SUNDRY NOTICES AND REPORTS ON WELLS

NASH UNIT # 29 SWD
EDDY COUNTY, NEW MEXICO
MARCH 16, 2009

Nash Unit #29
30-015-29434
XTO Energy
August 8, 2009
Conditions of Approval

XTO ENERGY - PROPOSED WITH CIBP REVISION

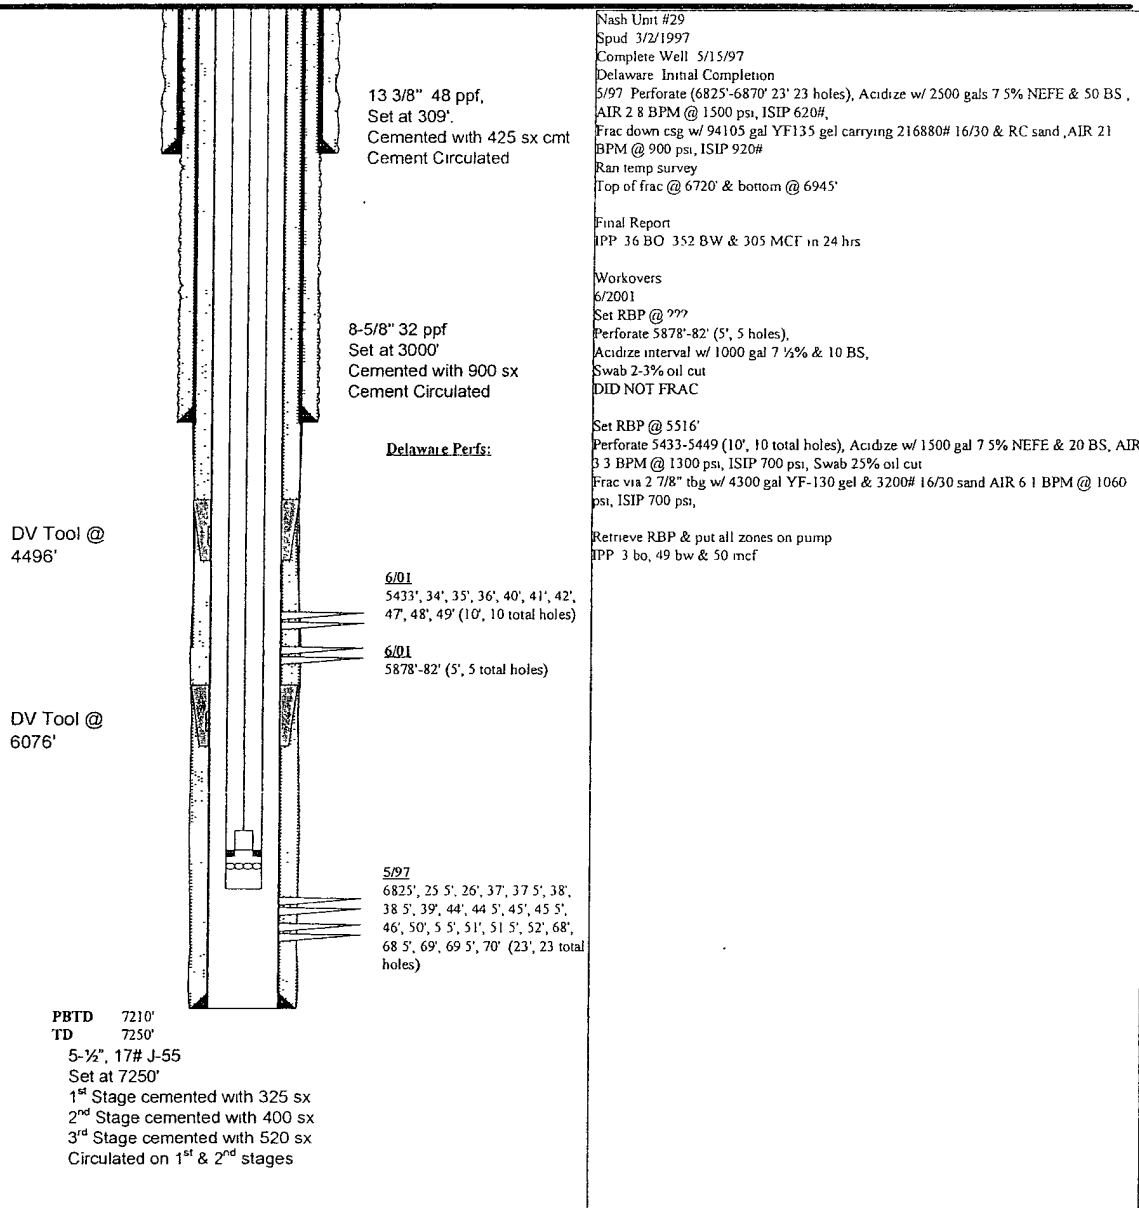
6. CIBP at 5400' is to have 35' of cement bailed or 25 sacks of cement pumped on top of CIBP.
7. Plug required across DV tool at 4496'. Plug to be set from 4550 – 4405' and must be tagged at 4405' or shallower. Plug to be 145' in length and a minimum of 25 sacks.

8. CIBP that was to be set at 3900' will need to be moved deeper as the BLM after further review will require that the Cherry Canyon be the injection interval. The CIBP will require 35' of cement bailed or 25 sacks of cement pumped on top.

9. Proceed with proposed procedure, but for the Cherry Canyon.
10. Subsequent sundry required detailing all work and when well was placed on injection.

DENIED. FORMATION CANNOT BE CHANGED
WITHOUT OLD APPROVAL.
